From: Samantha Lee [REDACTED]
Sent: 21 August 2019 11:46
To: Richard Castro-Parker
Cc: Daniel Vick
Subject: RE: BE/139/18/PL - Innovation Centre Beeding Close
Attachments: UNDA 100 Scale Layout.pdf; UNDA 400 Scale Layout.pdf; Souther Warter Sewer Records.pdf

**Location: Innovation Centre, Beeding Close, Bersted, West Sussex,
PO22 9TS**

88684-01

SEWER RECORDS PAGE 2 OF 2

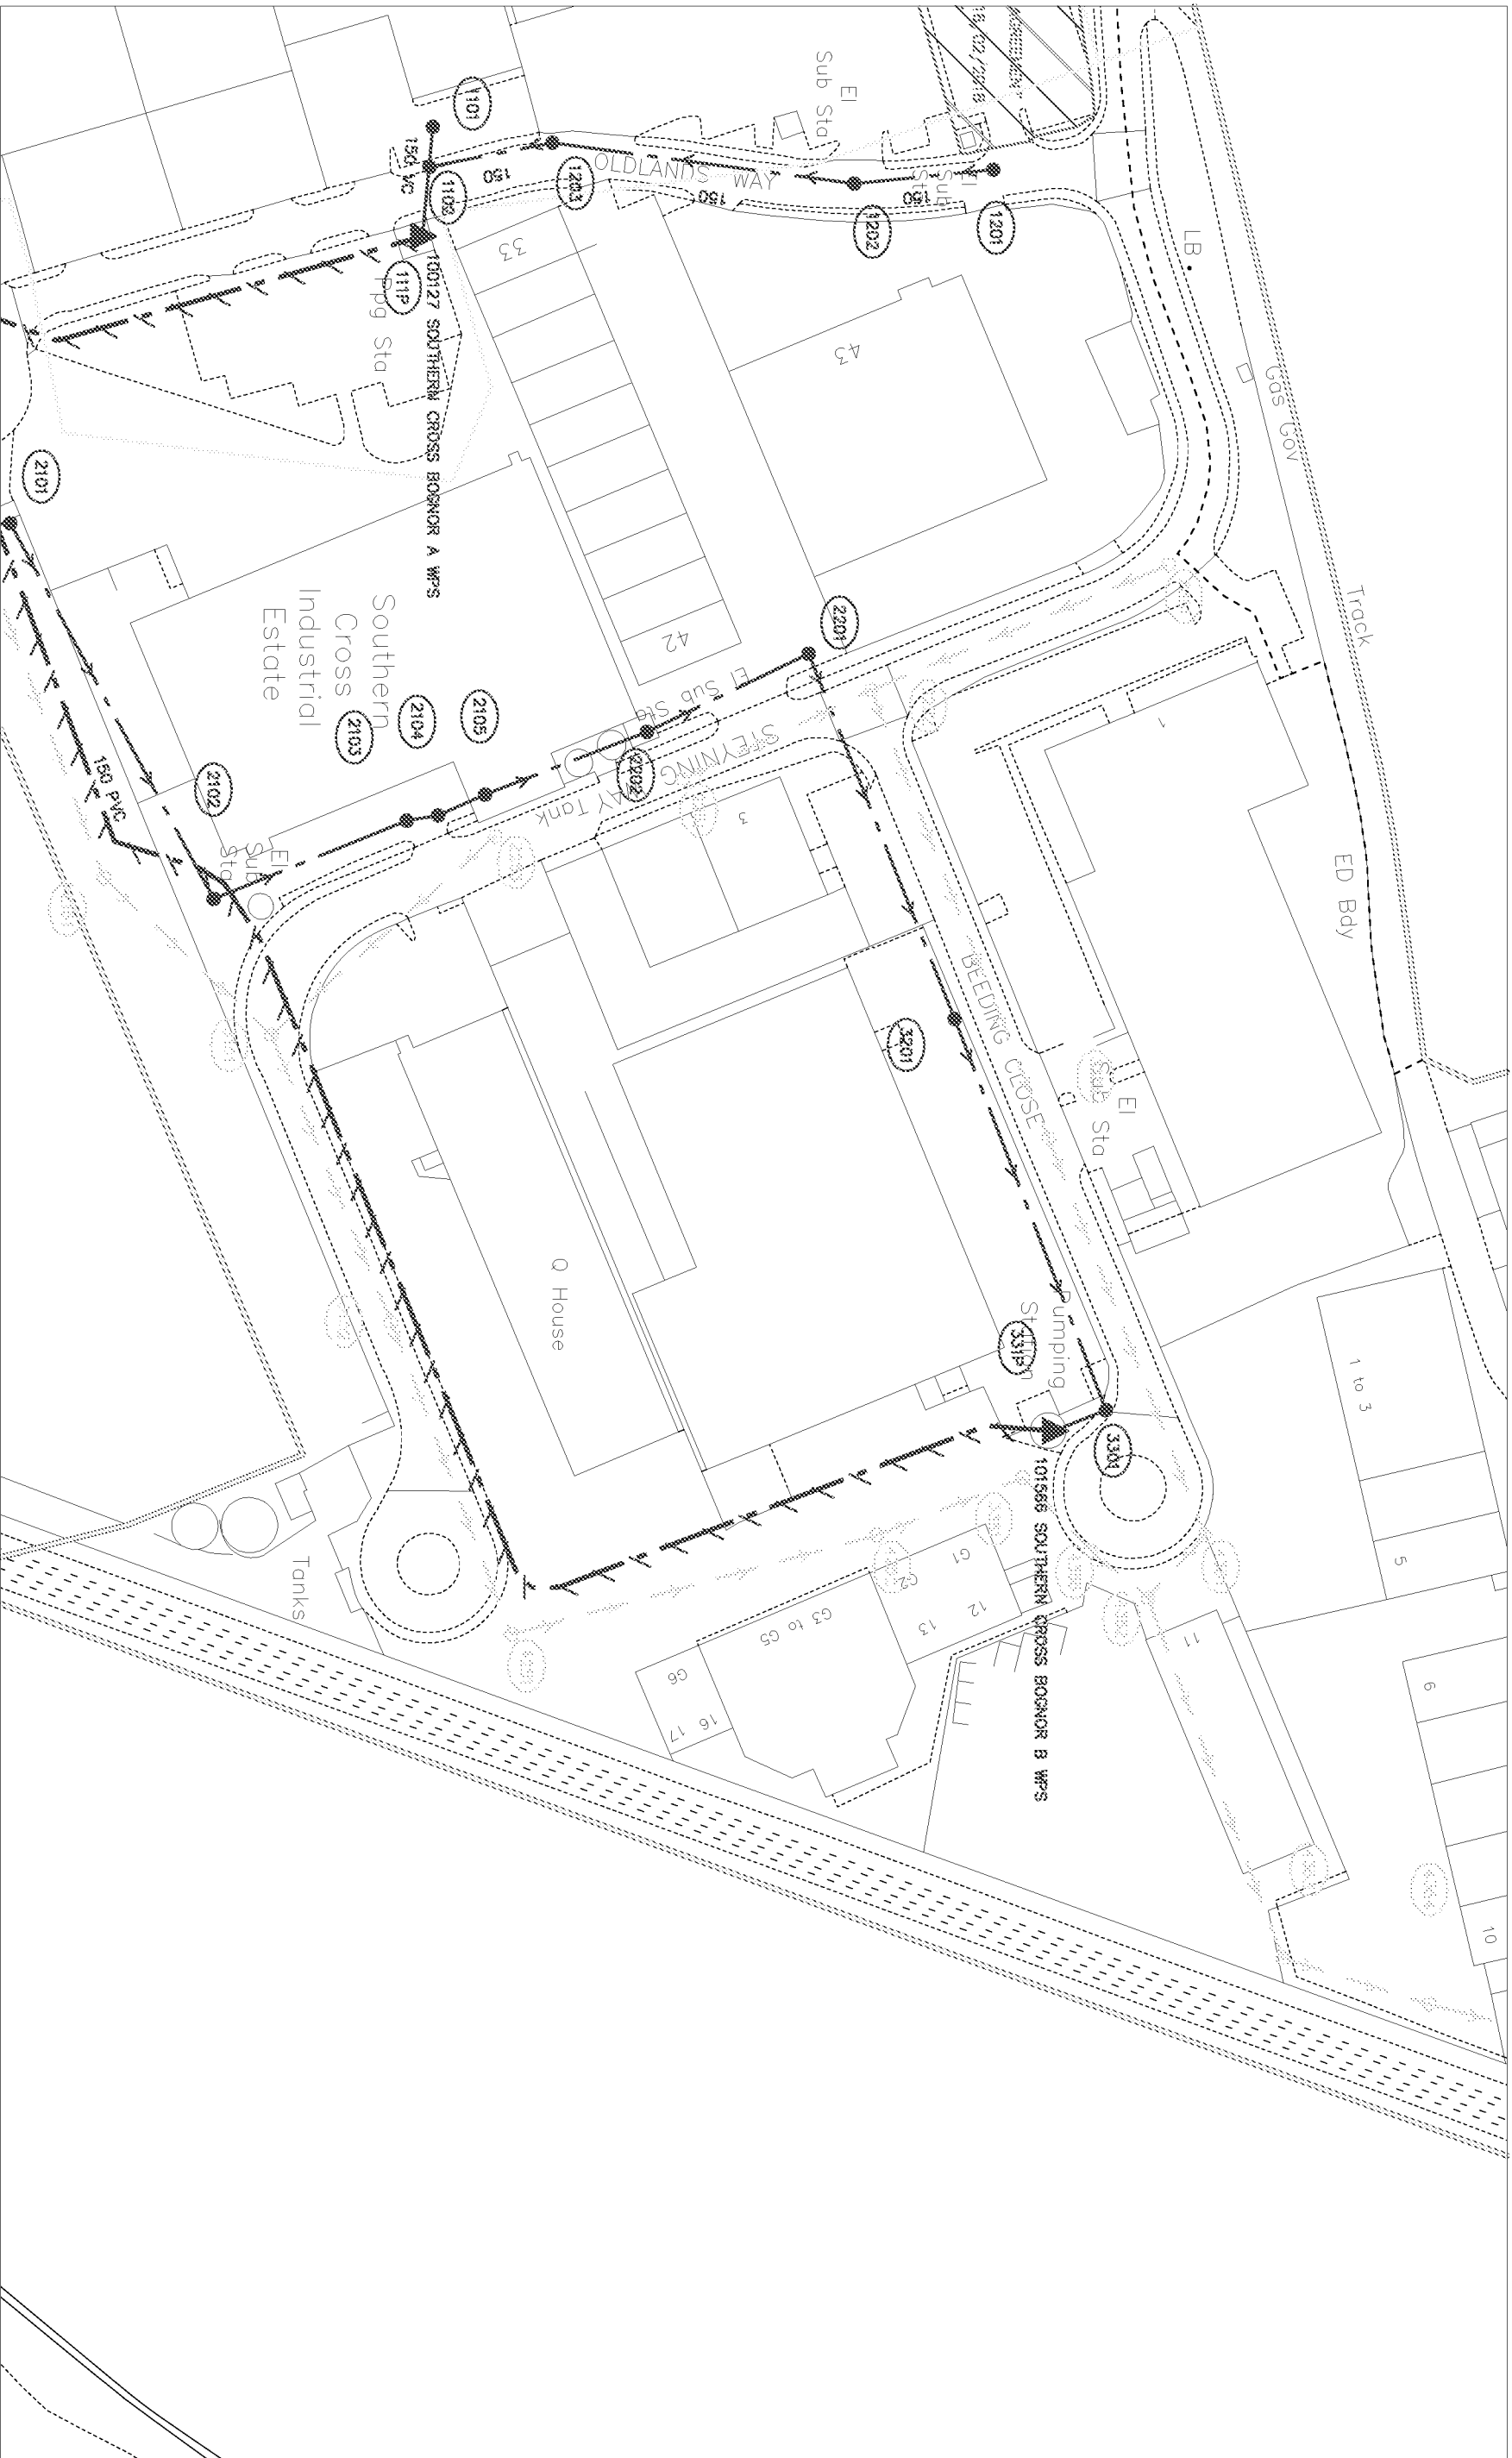
I also require levels to be submitted showing invert and cover levels of the existing drainage network and spot levels of the surrounding land. This is fundamental to ensure that the surface water from the development does not go off site.

With regards to levels, having reviewed the sewer asset location search requested from Southern Water, both invert and cover levels for all Southern Water manholes are detailed within their response. A copy of the sewer asset location search was included within the appendix of the Surface Water Drainage Strategy -- this have been attached to this email for her reference.

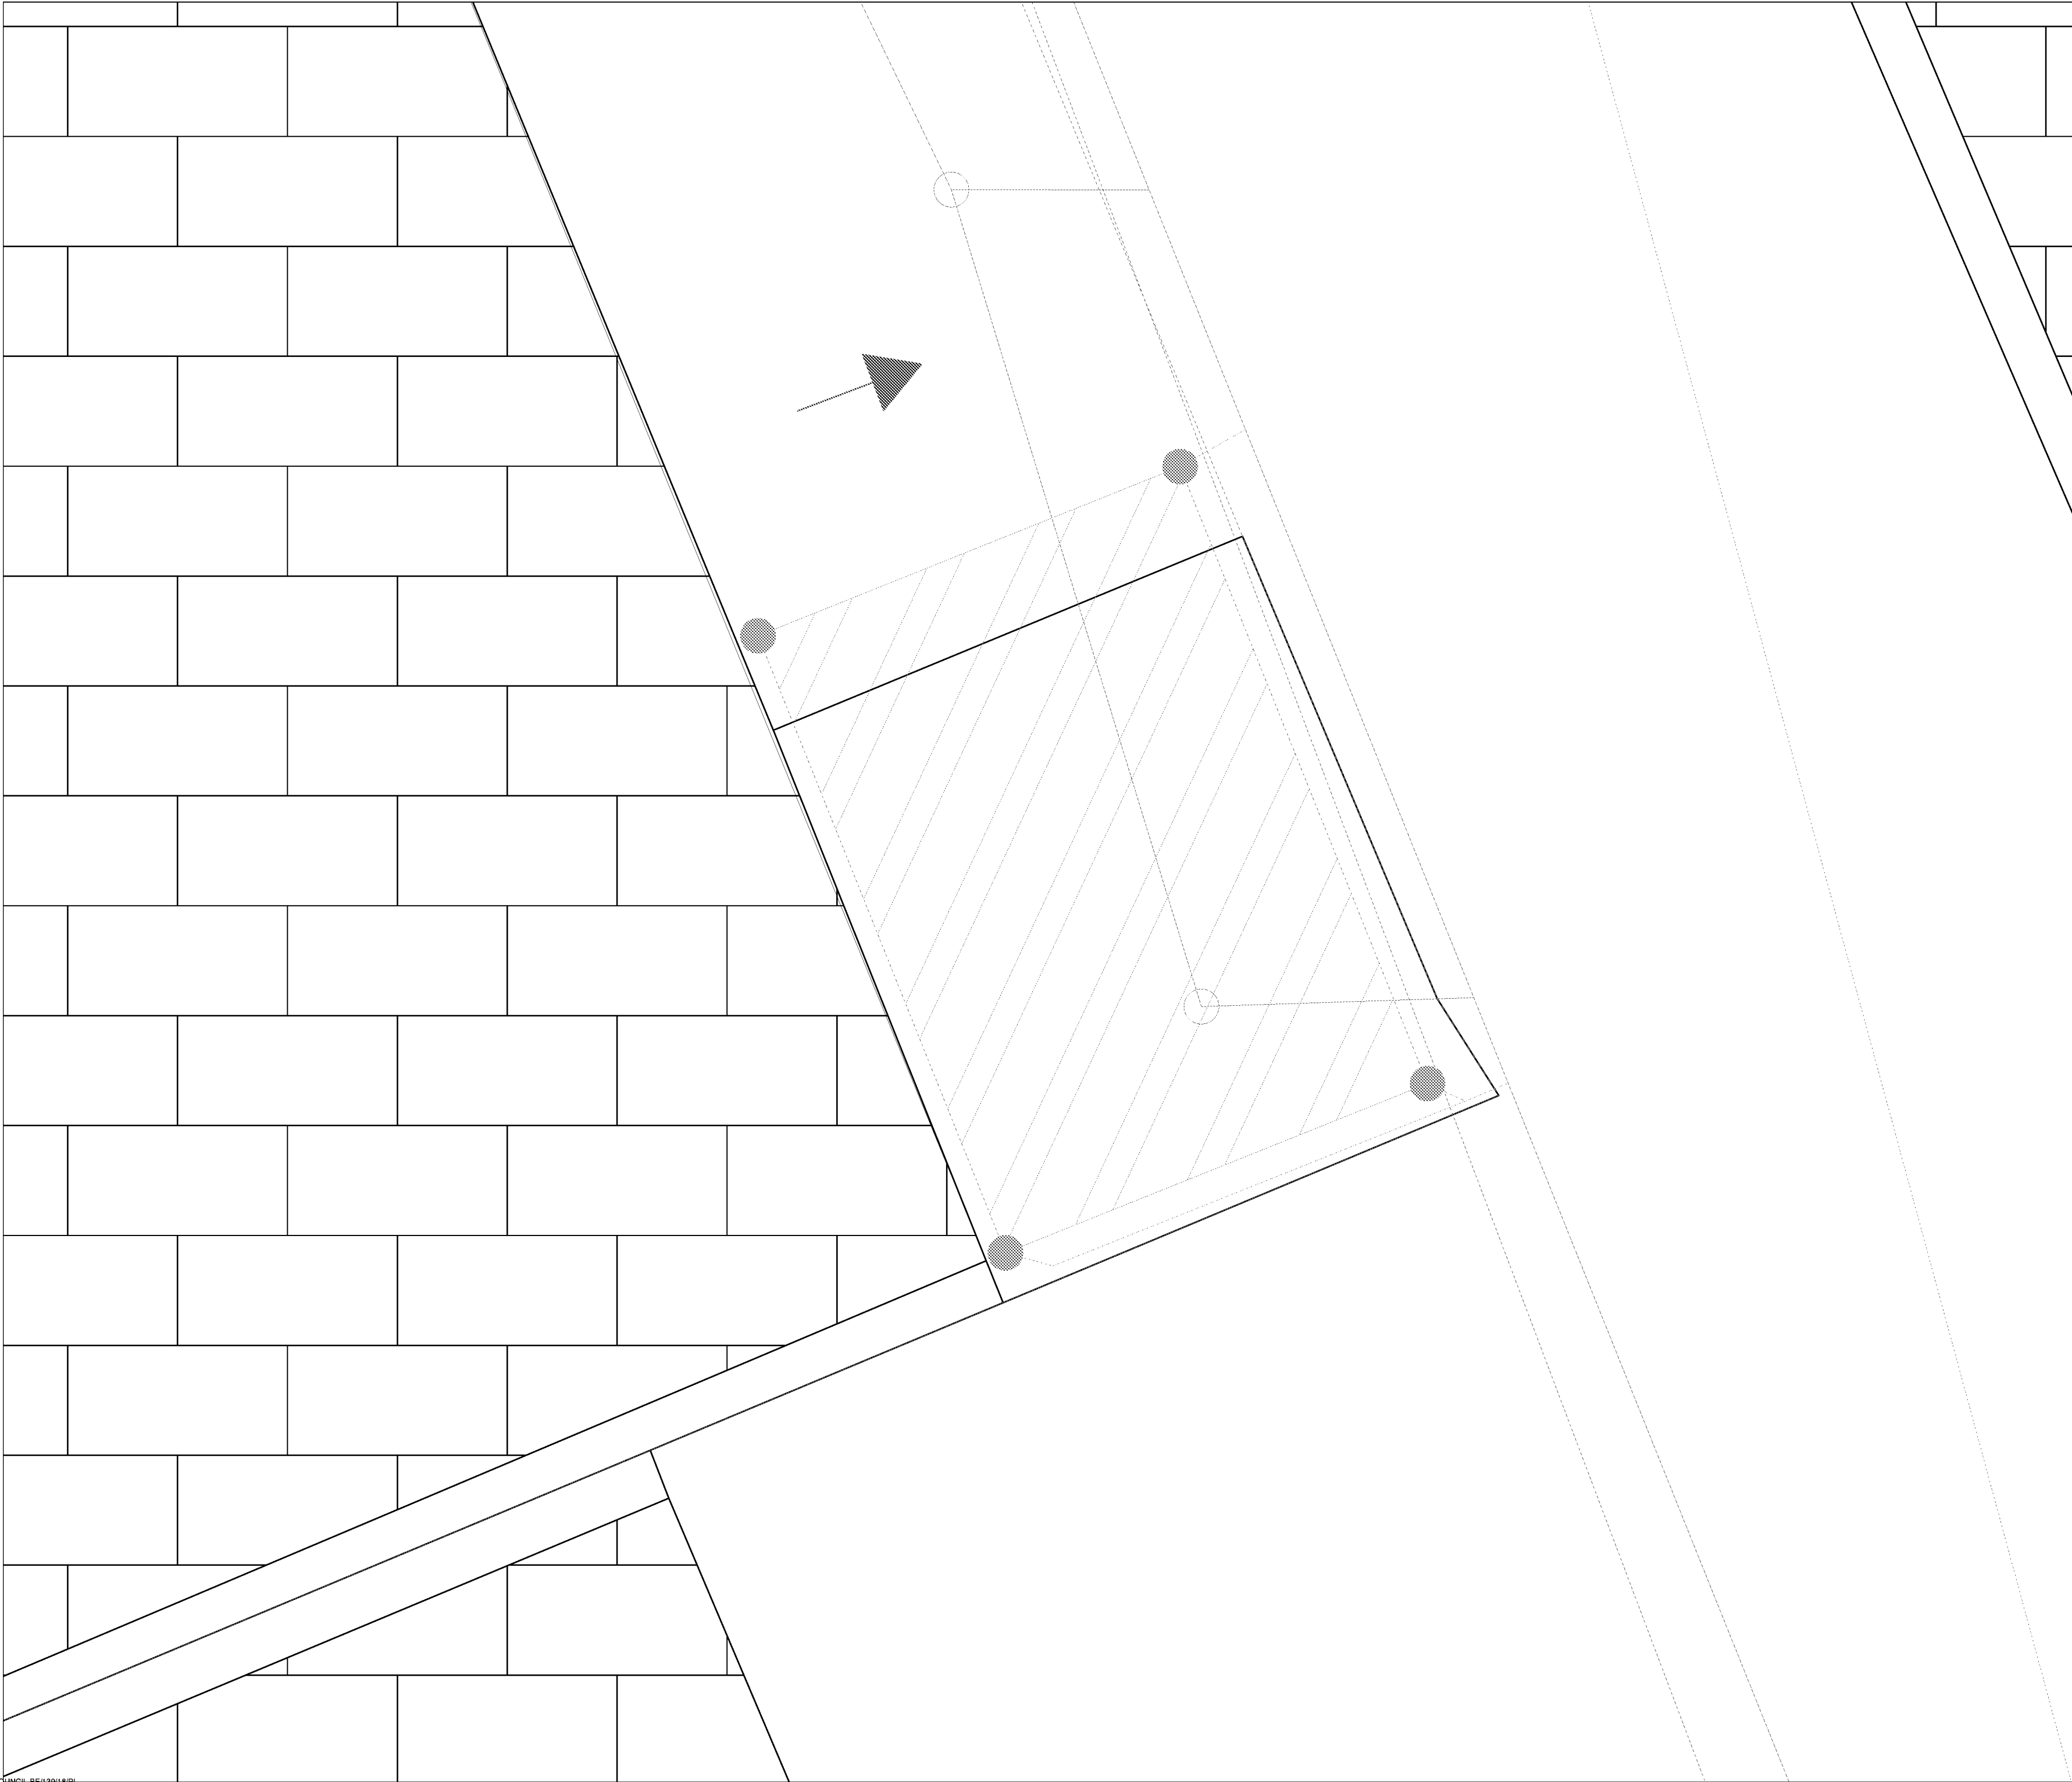
Please can the applicant submit clearer plans of the proposed surface water drainage arrangement. I.e. different line types used, rather than all very similar colours. Please can gullies, manholes, and linear drainage channels be clearly labelled.

Please find attached a PDF of the drainage layout plan for the site. Given the size of the site, all lines on the plans are small. However, if Laura zooms in she will be able to distinguish between the pipes types. This should hopefully address her first concern.
